To: ALL BIDDERS
From: Kenneth Dudley, Taylor County Engineering Division
Date: December 9, 2011
Re: Keaton Beach Coastal Park - Ramp Parking Project
Addendum No. 1

This memorandum is to serve as a Contract Addendum to the **KEATON BEACH COASTAL PARK** project bid package to be accepted by the Board of County Commissioners on December 13, 2011.

TURFSTONE PAVER DETAIL

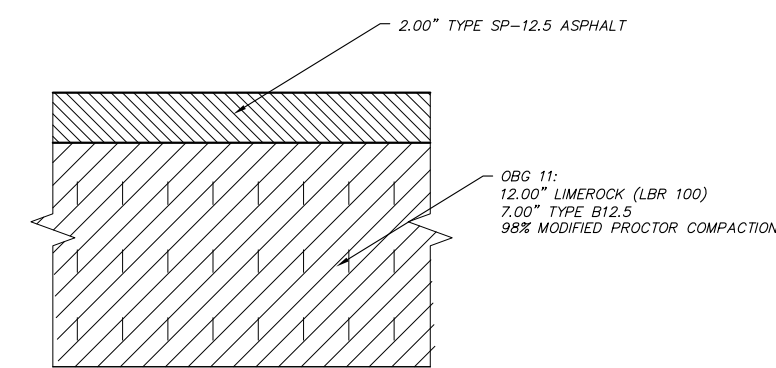
1. **The Plan Set Detail Sheets have been revised and posted on-line at <http://www.taylorcountygov.com/Bids/Index.htm>. The ADA Parking Sign detail and the Turfstone Paver Detail have been updated.**

2. **The Turfstone Paver Bedding Layer will make use of No 8. Stone for both construction options as they are constructed over an open-aggregate base. See specifications for additional information.**
